H.B. Robinson #2

September 17, 1975

File: NG-3514 (R)

H. B. ROBINSON UNIT NO. 2
LICENSE NO. DPR-23
LOCKOUT OF CRITICAL ECCS VALVES

FIGURE 1

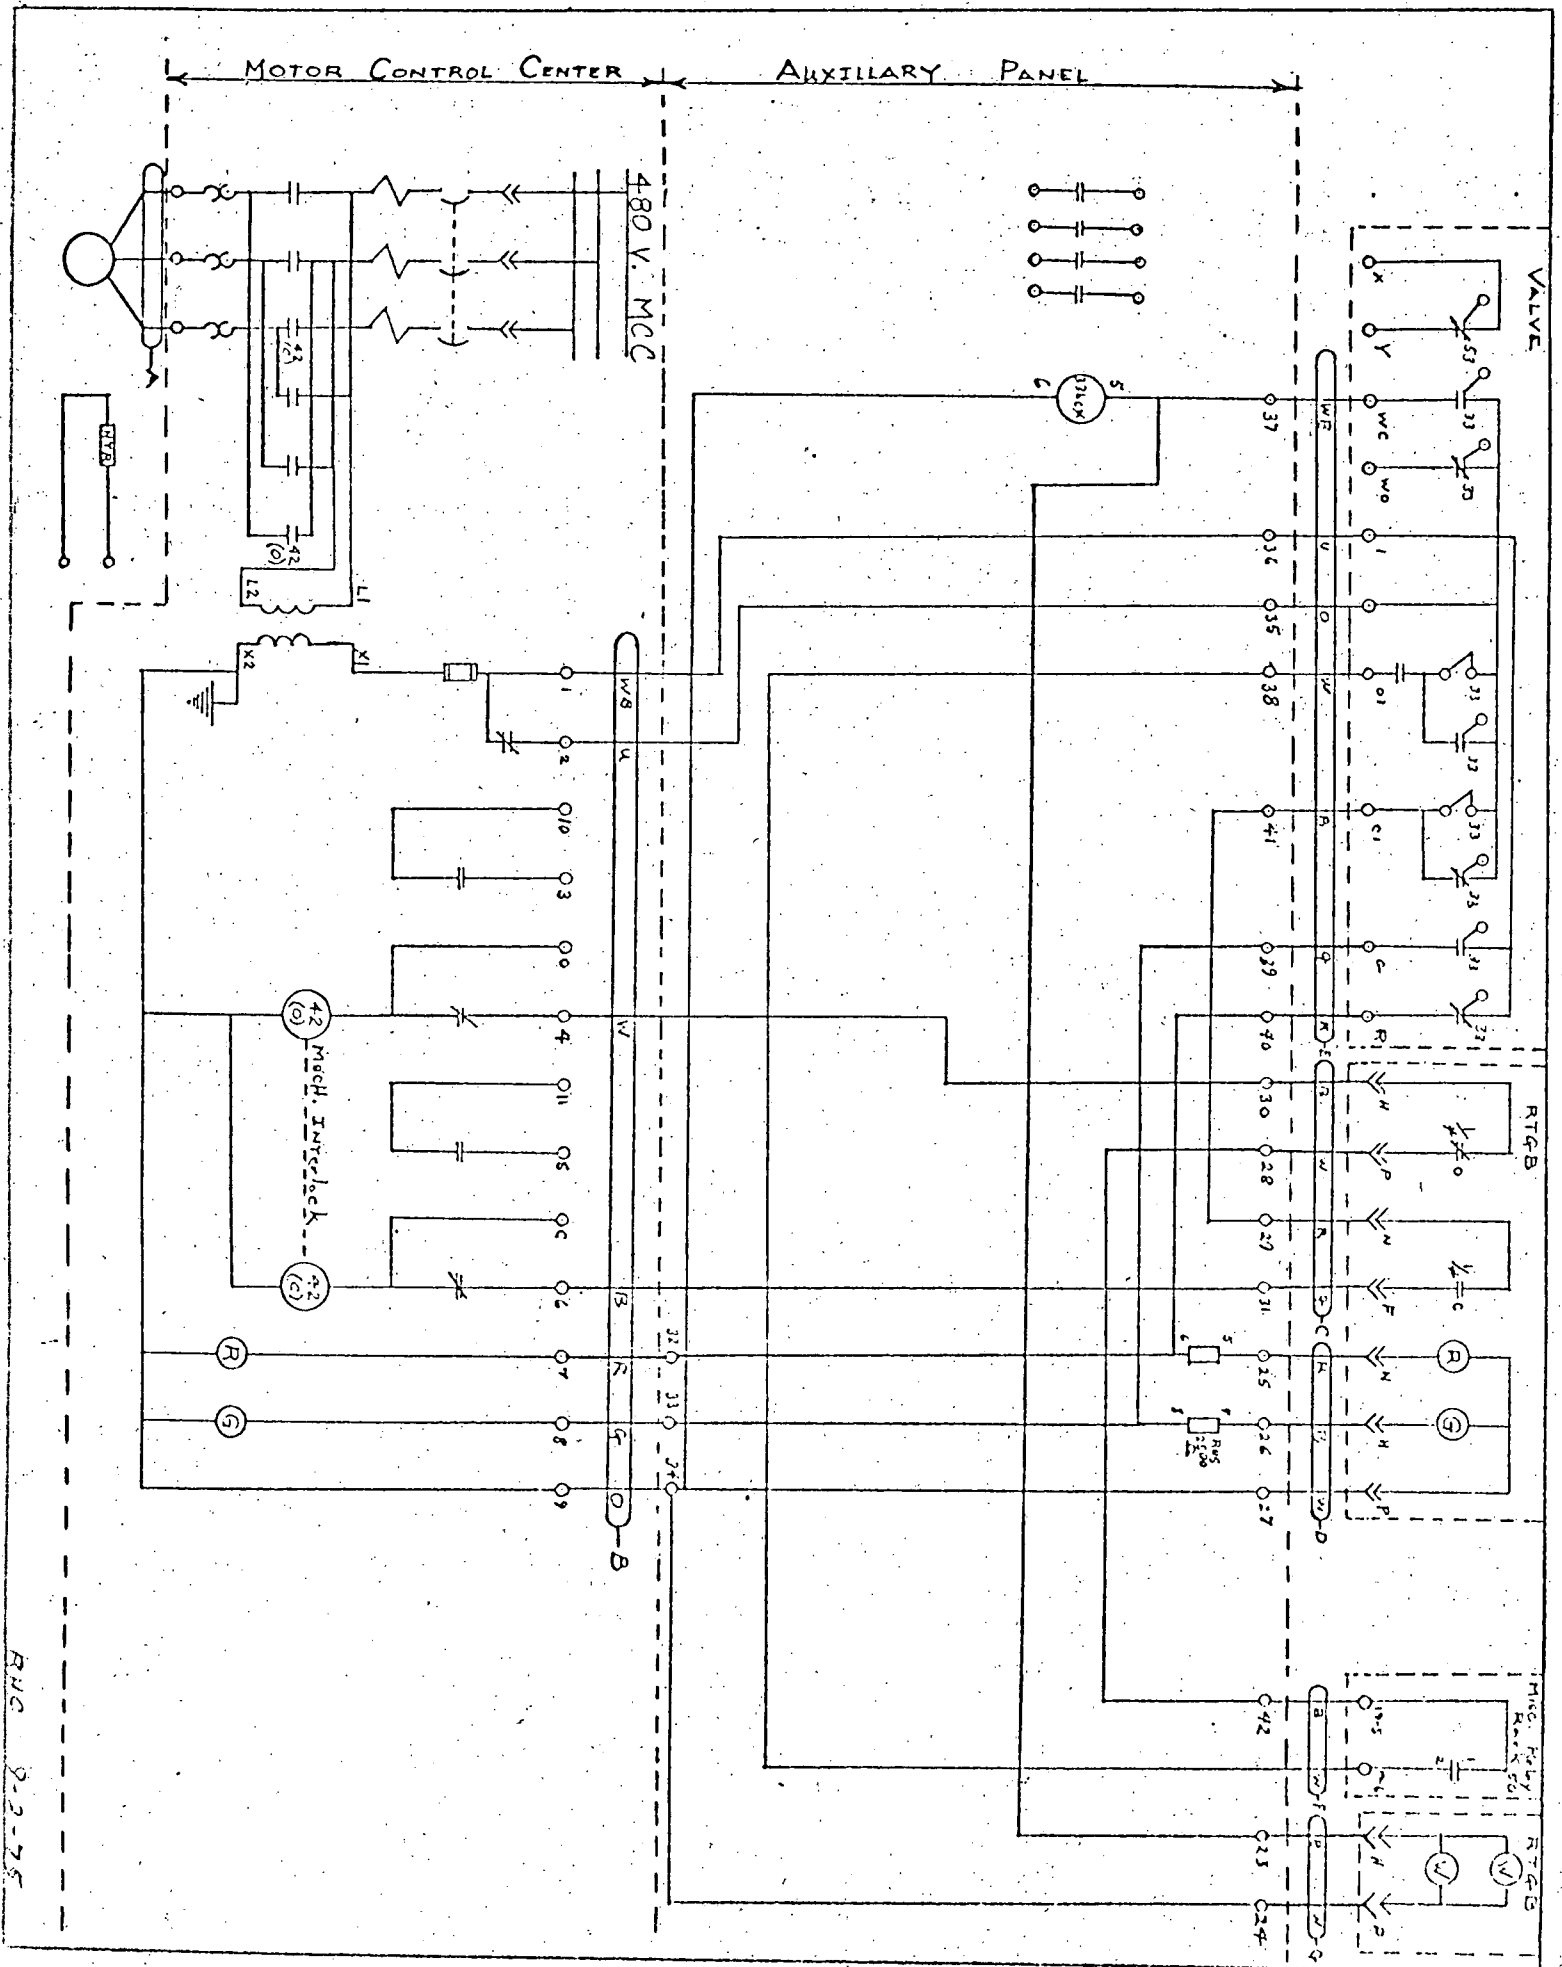
The proposed modification will require the use of one key switch per valve. This is permitted by a wiring design in which no single electrical failure could create an inadvertent valve operation, while the key switch prevents inadvertent operator action. The attached Figure 1 shows a typical Control Wiring Diagram for a valve motor operator as presently configured, and Figure 2 shows the proposed addition of the key switch and associated wiring.

PROPOSED CONTROL WIRING DIAGRAM
FOR LOCKED VALVE
FIGURE 2

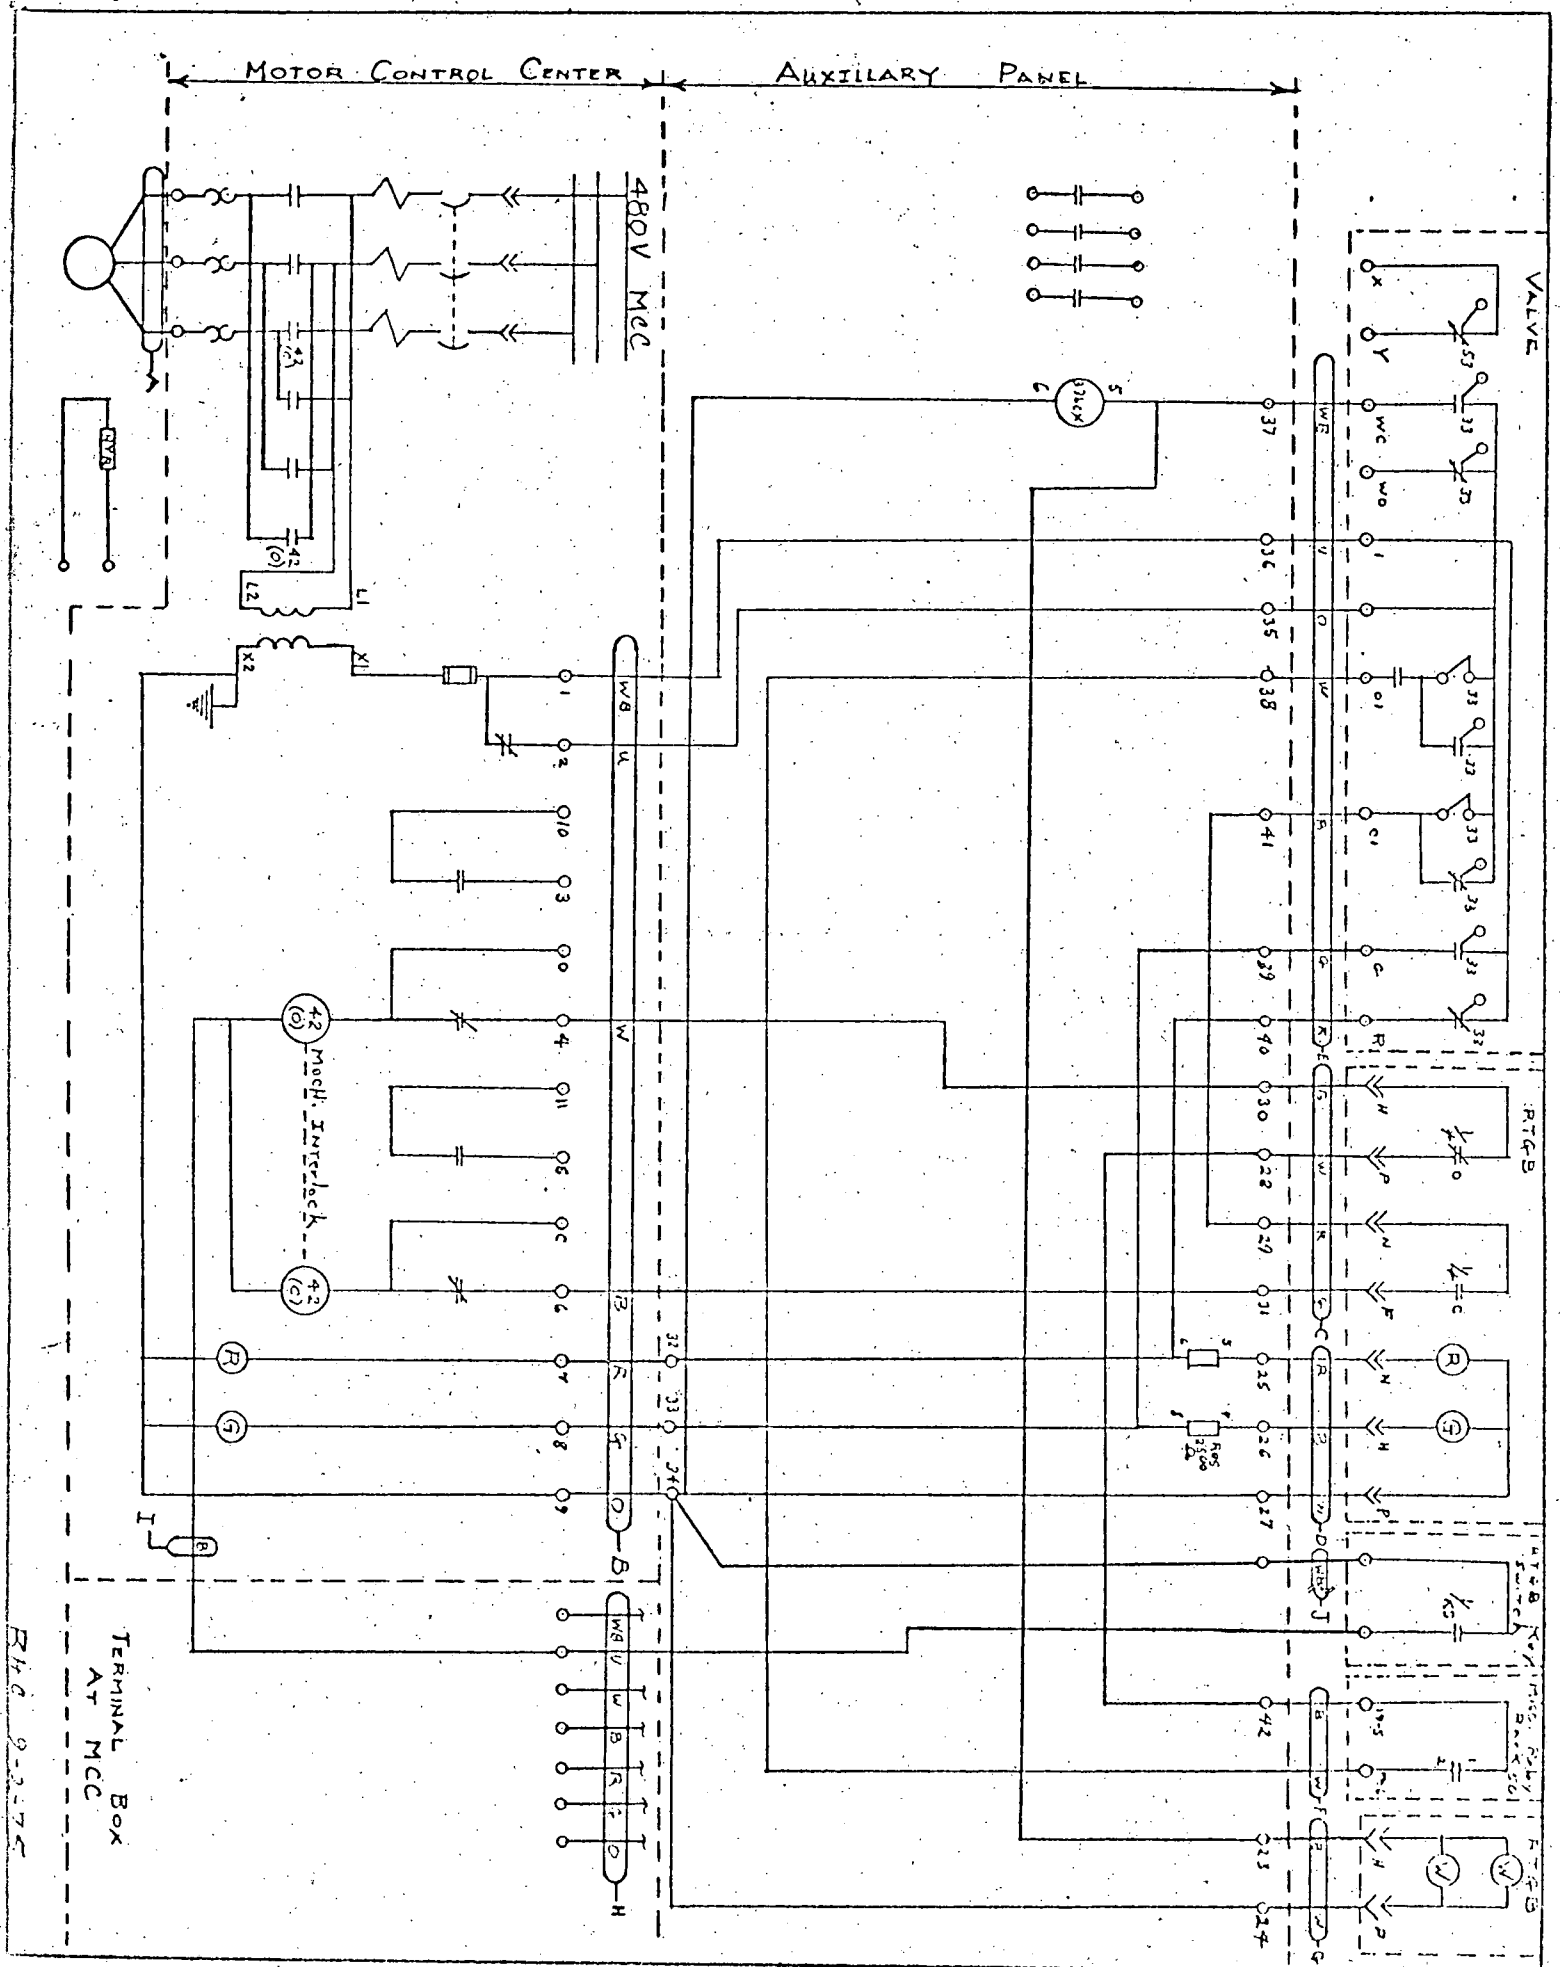
The cables for all the valves listed in attached Table 1 would be run as a multiconductor cable from the terminal block at the respective MCC's to key switches mounted on the RTGB. Another multiconductor cable would be run from the RTGB to the auxiliary panel, where each conductor would be attached to the ground of the appropriate valve, as shown in Figure 2. A failure of either of the two cables, by shorting or severing, would not result in the bypass of the key switch or actuation of the valve. A short of the key switch itself would unlock the valve, but operation of the valve would be prevented by the manual switch. Periodic checks of the key switches will be performed during each refueling outage to assure their operability. Flame retardant wiring or wire coating will be used in the modification.
